Adjusting A Multiple-Boiler System

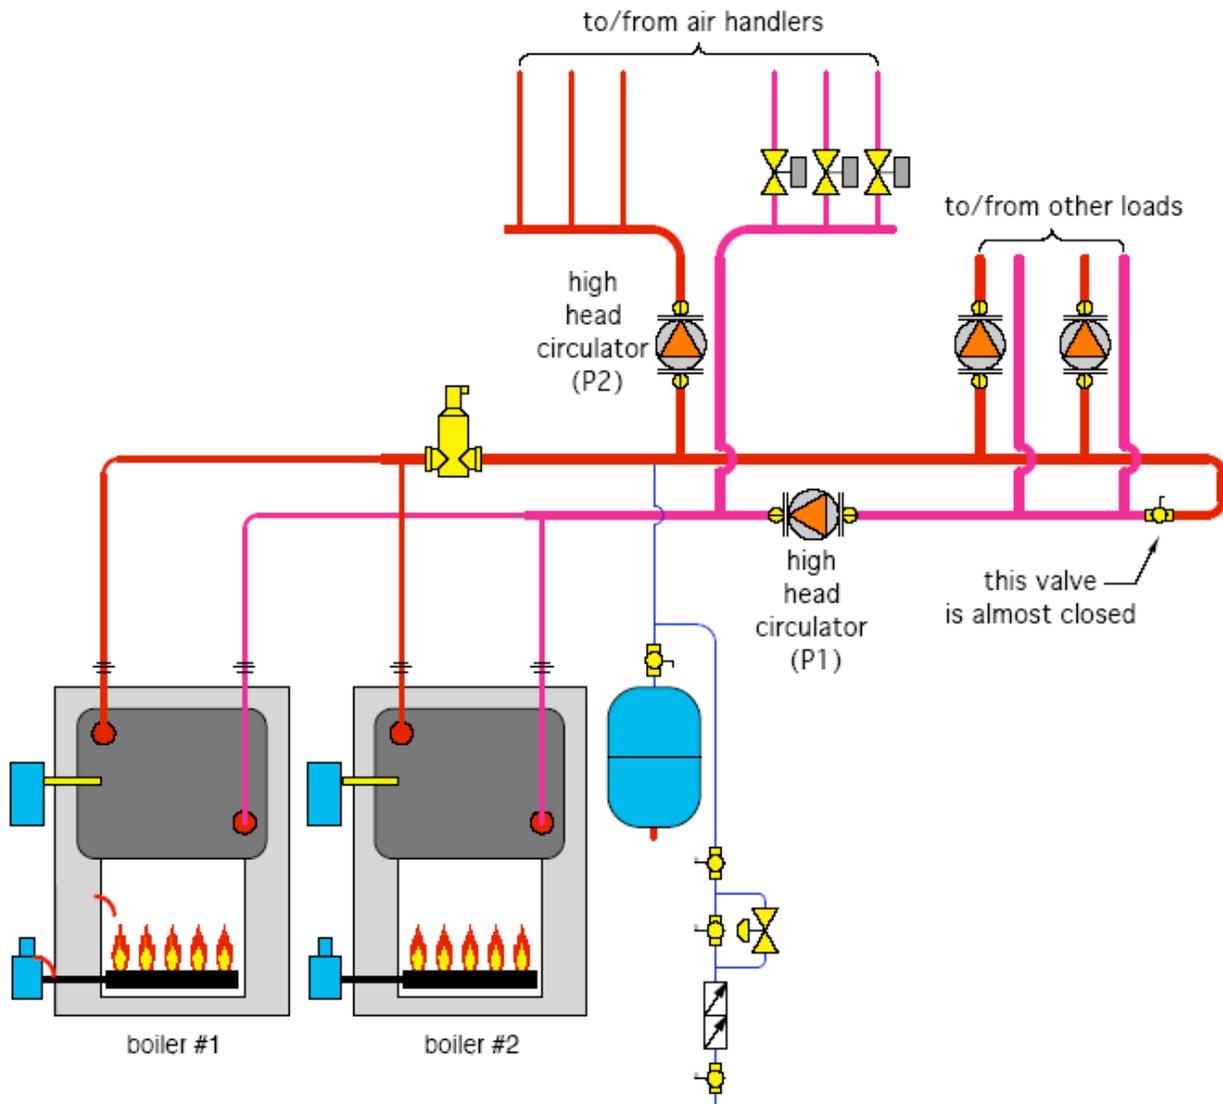
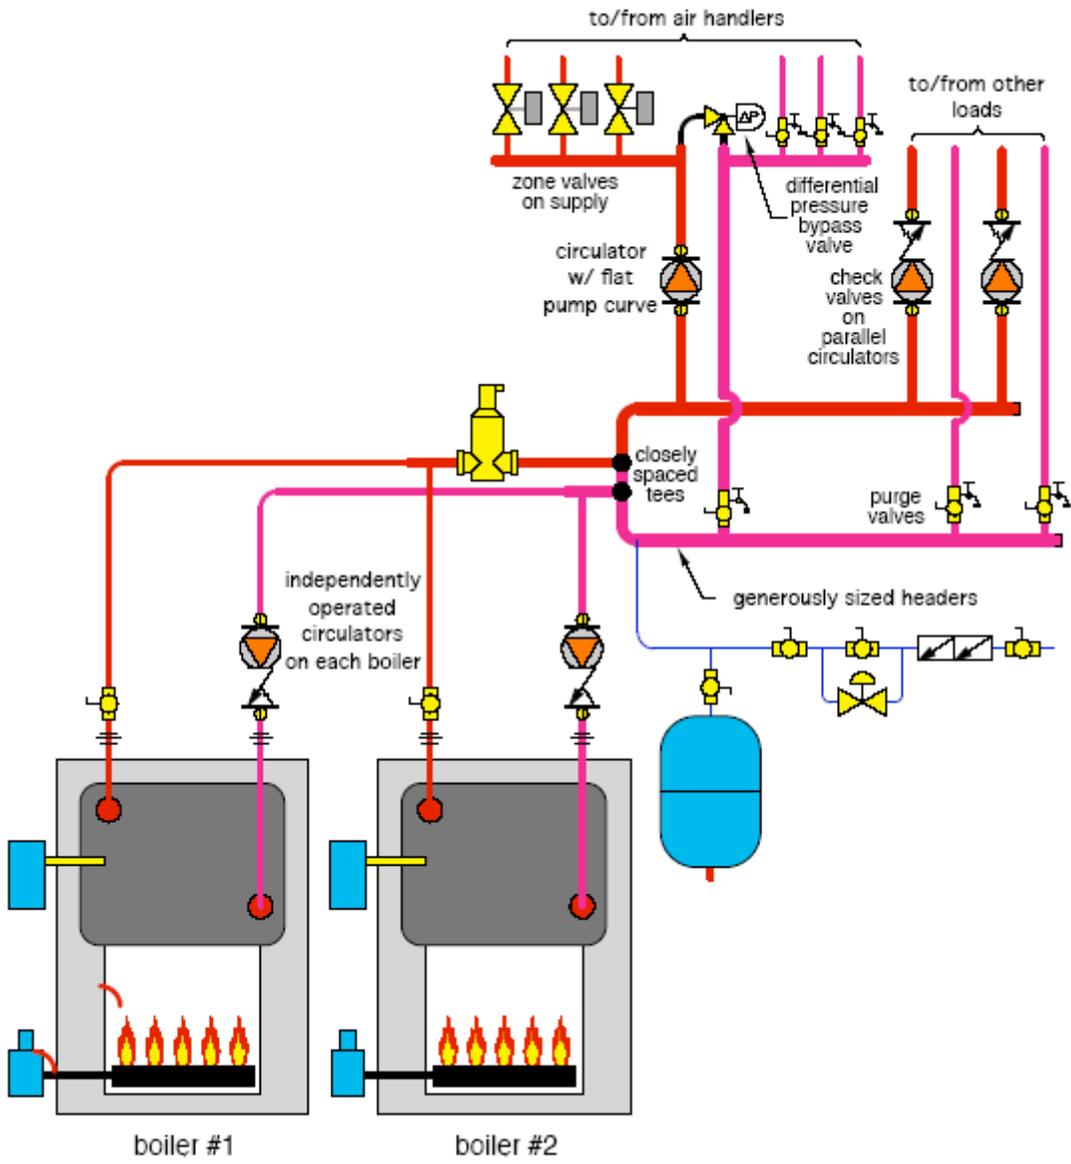
A few years ago, I toured a facility with a hydronic heating system laid out as shown below. The systems supplied some air handlers using valves for zone control. It also supplied two other higher temperature loads using separate circuits with individual circulators. The system was supplied by two cast-iron atmospheric boilers.

There is no way the original system can do this.

Another error is the use of high head circulators with zone valves. This is never a good idea. It produces wide variations in differential pressure depending on which zones are operating. If a fixed speed circulator will be used with zone valves, it should have a flat pump curve. A differential pressure bypass valve should also be installed across the headers to help minimize variations in differential pressure.

The original distribution system is an "aberration" — a mix between a pumped boiler loop, and parallel circuits piped "across the mains." The partially closed ball valve at the end of this loop will create a differential pressure across the mains that will drive hot water through inactive zone circuits.

Finally, the two zone circuits on the right side of the original system do not have flow check valves or purging valves.

The solution is to install a separate circulator and flow check on each boiler, and wire them to operate only when their associated boiler is providing heat to the system. In The Fix drawing, I've shown circulators with integral check valves mounted with the check valve under the circulator. This reduces the possibility of air being trapped in the circulator by the check valve. Ball valves are also provided to allow each boiler to be isolated if necessary.

Zone valves should be located on the supply side of the zone circuits to help prevent heat migration into inactive zone circuits.

Purging valves should be provided on all circuits.

There is absolutely no reason to use such a valve. The situation is corrected by a simple pair of closely spaced tees in combination with generously sized headers. This provided effective hydraulic separation between all the circulators, and eliminates the need for a primary circulator.
